**PLANNING PERMIT APPLICATION PA2016/5118 AND  
WORKS APPROVAL APPLICATION 1002191 –  
EXTENSION TO THE LANDFILL AT 408-546 HOPKINS ROAD,  
TRUGANINA AND 1154-1198 CHRISTIES ROAD, RAVENHALL  
Amended Submission by Melton City Council, August 2016**

Item 12.6 Planning Application PA 2016/5118 - Extension of the  
Melbourne Regional Landfill At 408-546 Hopkins Road,  
Truganina and 1154-1198 Christies Road, Ravenhall  
Appendix 1 Appendix 1 - Amended landfill submission

5.3 Buffer Plan

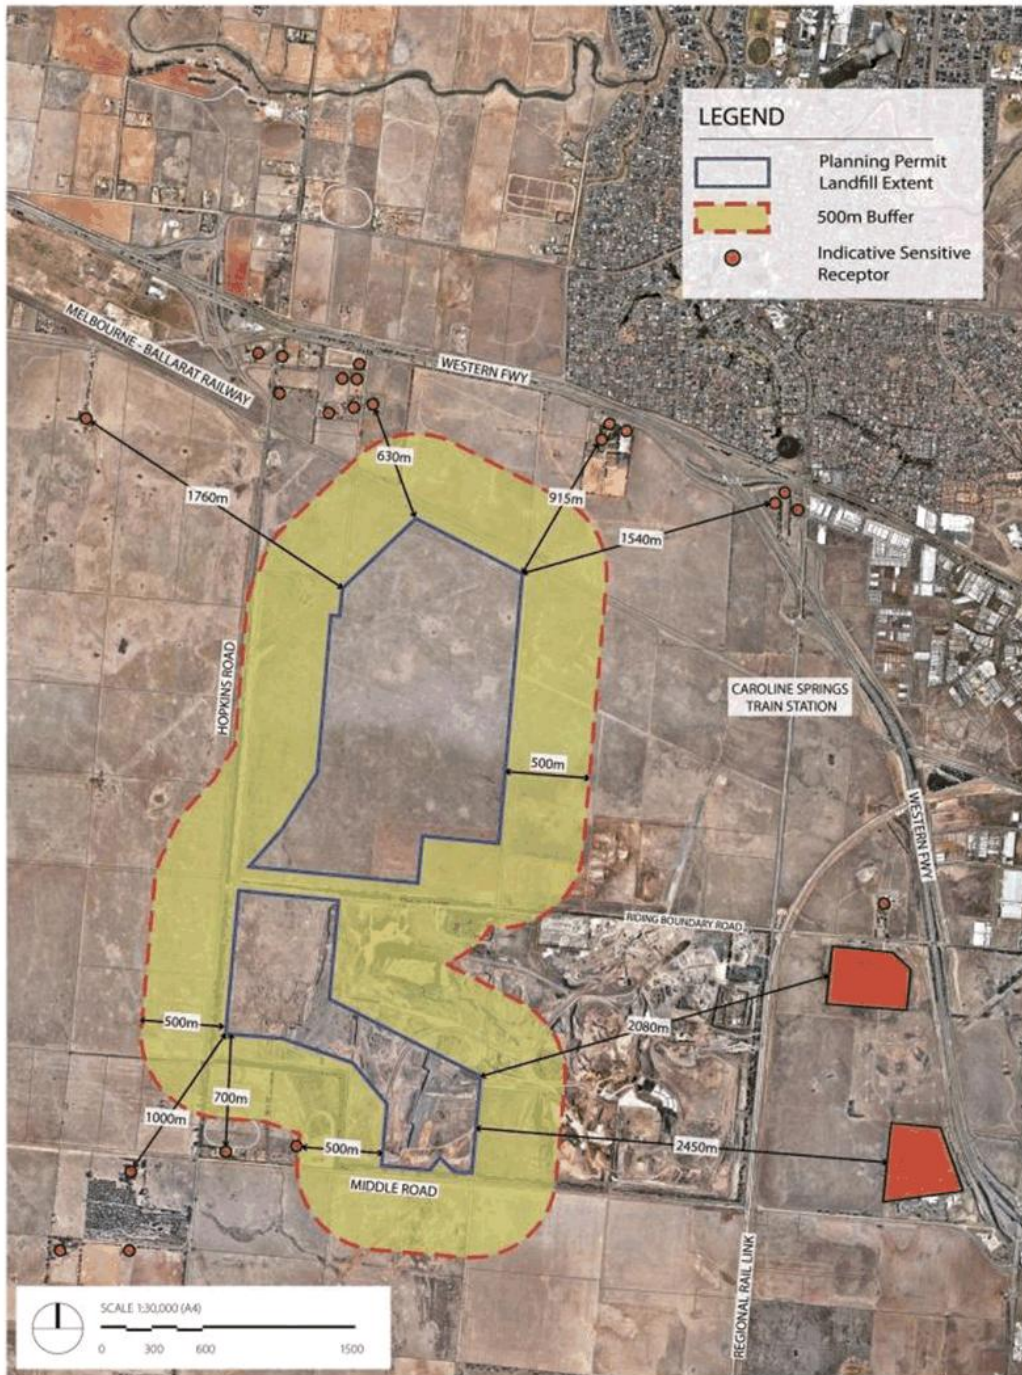
Given the complexities of the proposal, it is Council's view that the buffers which affect the PSP area should be moved to be located entirely on the landfill site. This would require a boundary change to the cells proposed as part of the Applications.
